STATE OF MAINE
DEPARTMENT OF TRANSPORTATION
16 STATE HOUSE STATION
AUGUSTA, MAINE 04333-0016

May 13, 2022
Subject: Bucknam Road Bridge
Replacement, Intersection Improvements &
Johnson Road Bridge Replacement
State WINs: 021720.00, 021721.00 &
022672.00
Location: **Falmouth**
Amendment No. 2

SHEET NUMBER
61
OF 62

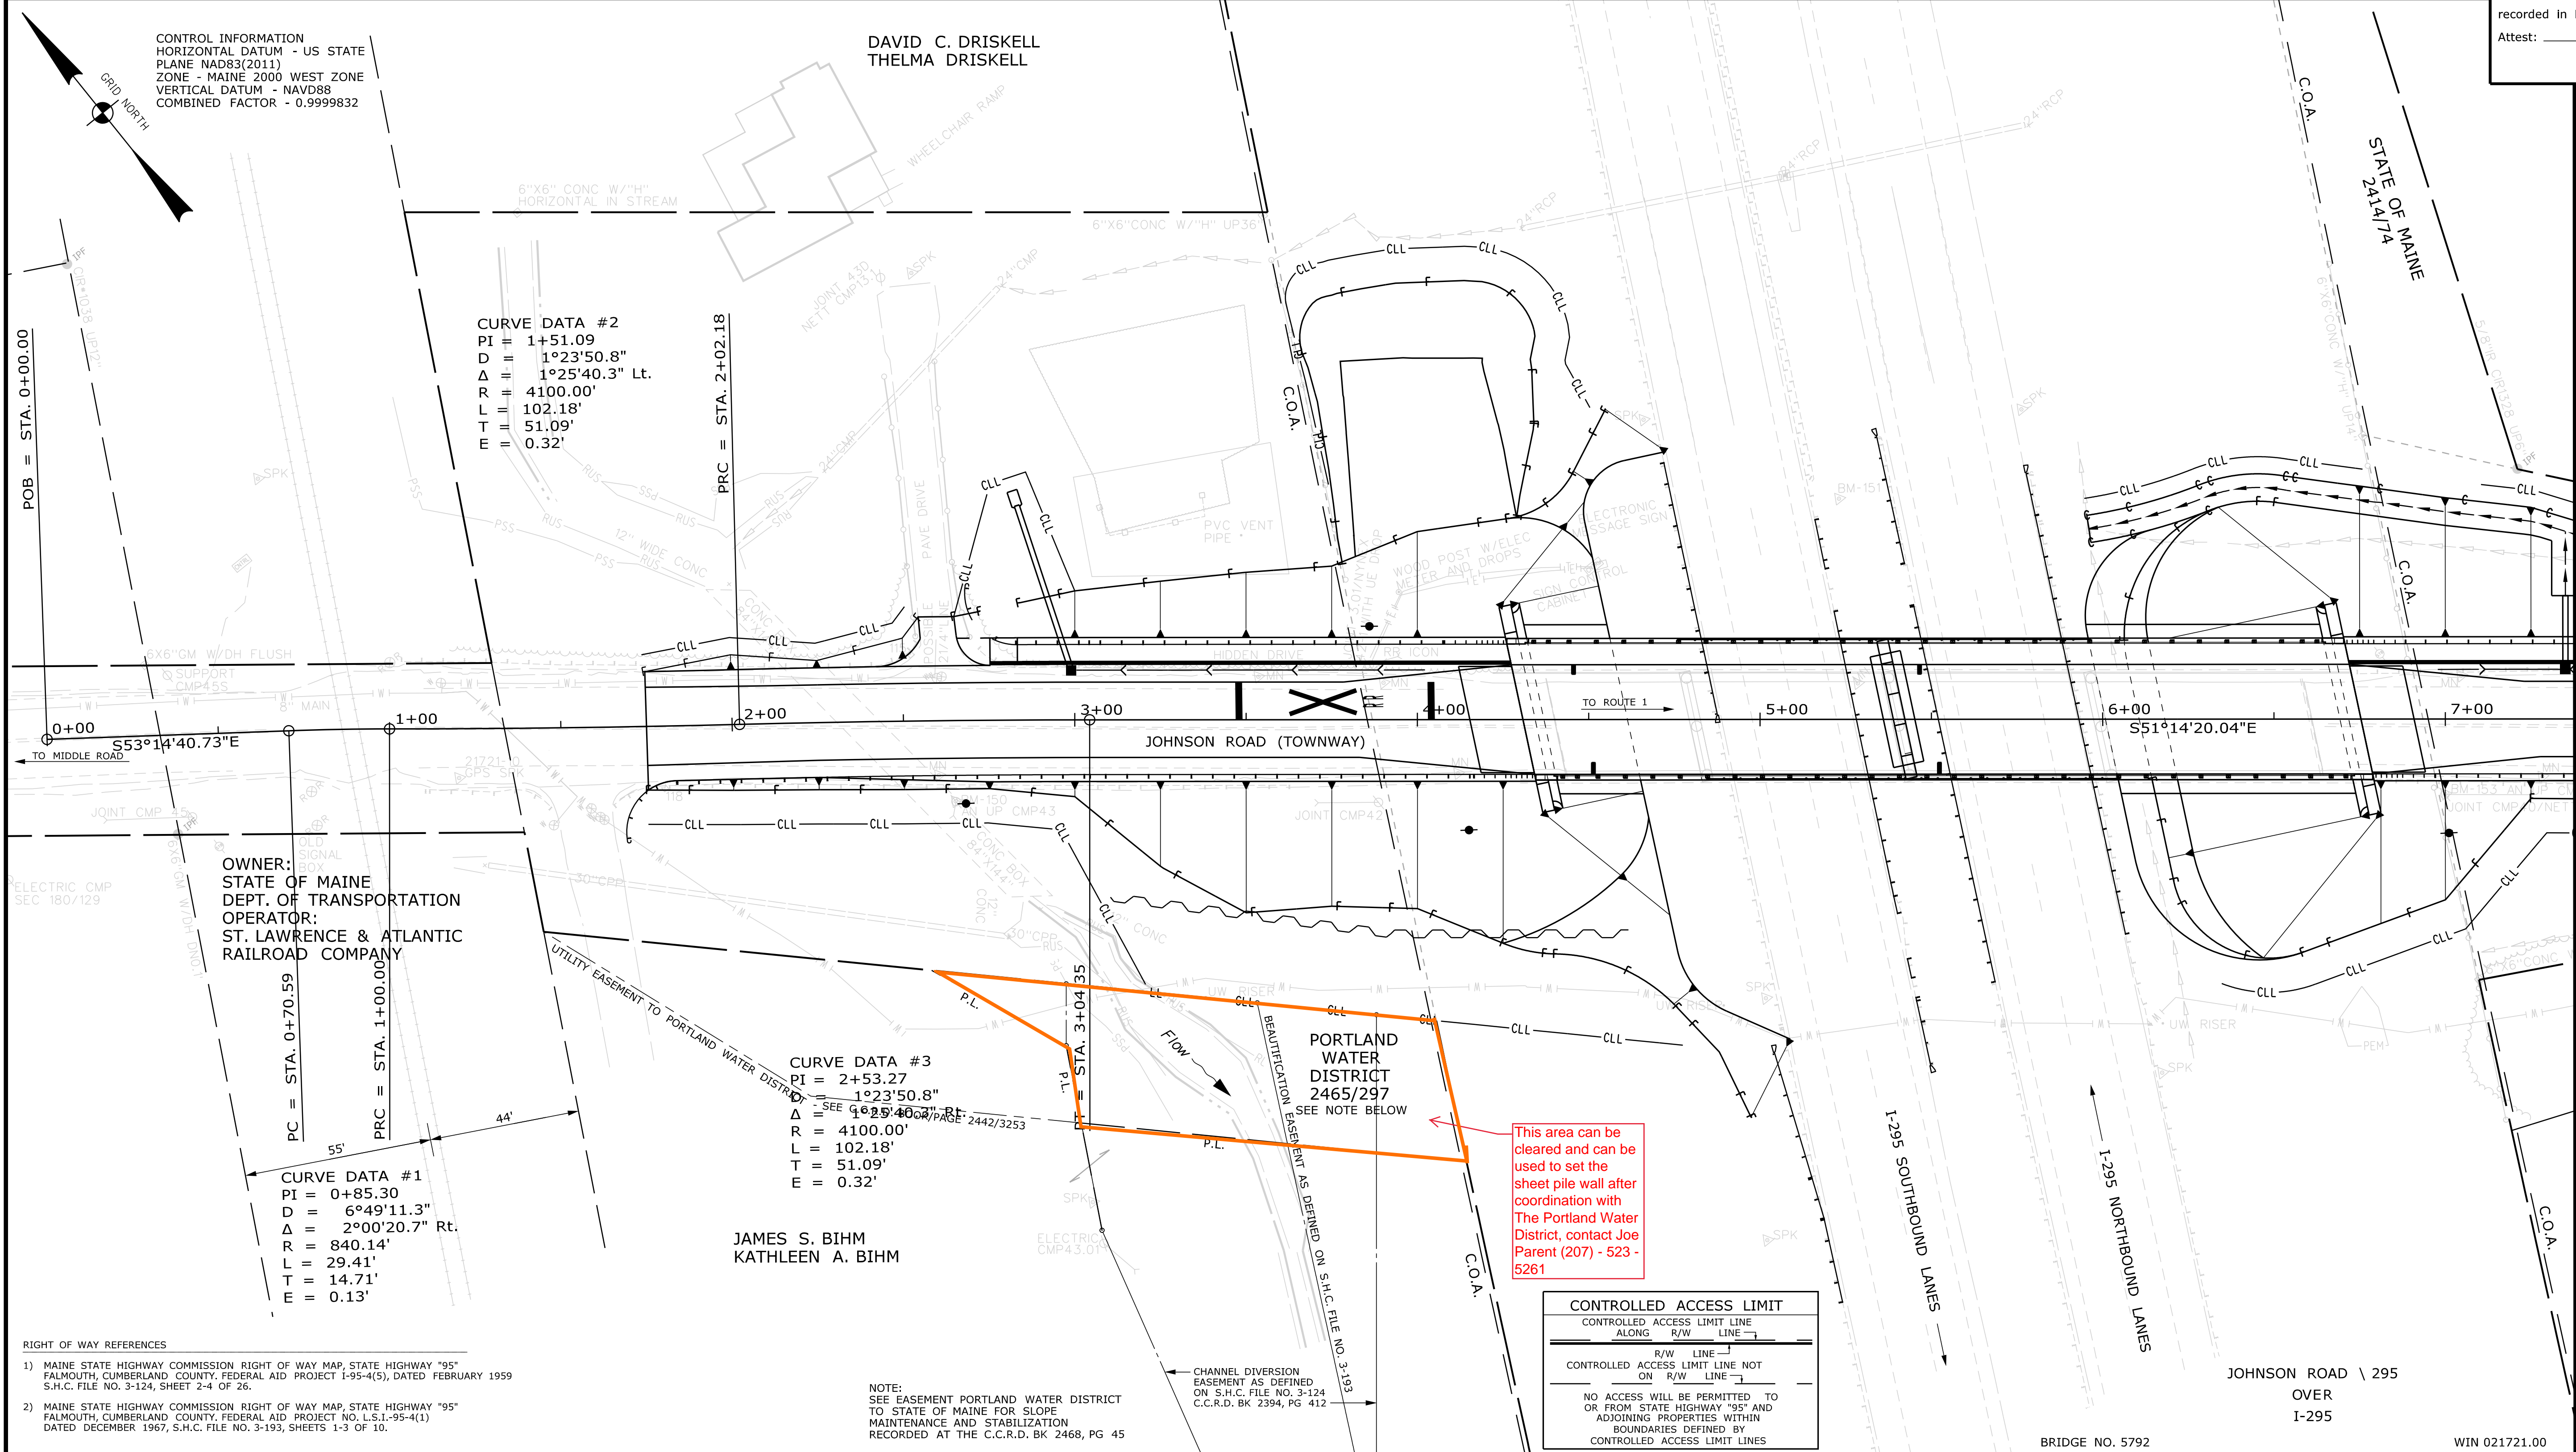
For WIN 21721.00, **REMOVE** SHEET NUMBER 61 OF 62, RIGHT OF WAY MAP, and **REPLACE** with the attached, revised SHEET NUMBER 61 OF 62, RIGHT OF WAY MAP.

Question: We are in receipt of Amendment No. 1, thank you. We had asked for the Department to provide the Portland Water District ROW referenced in SP501 Slope Stabilization Steel Sheet Piling. The ROW plans provided in Amendment No. 1 do not clearly define where the Portland Water District ROW is. Please provide a plan showing the Portland Water District ROW in the area of the sheet pile wall so that we can determine access for pile driving equipment.

Response: Please reference in the bid book, page 64, Special Provision - Section 104 - Utilities, the 5th paragraph. The easement noted on Plan Sheet 61 (Book 2468, Page 45) is an easement granted to the Maine Department of Transportation for grading and slope stabilization on the Portland Water District's property. The easement gives MaineDOT the right (within the restrictions of the easement) to enter that property for grading and slope stabilization purposes.
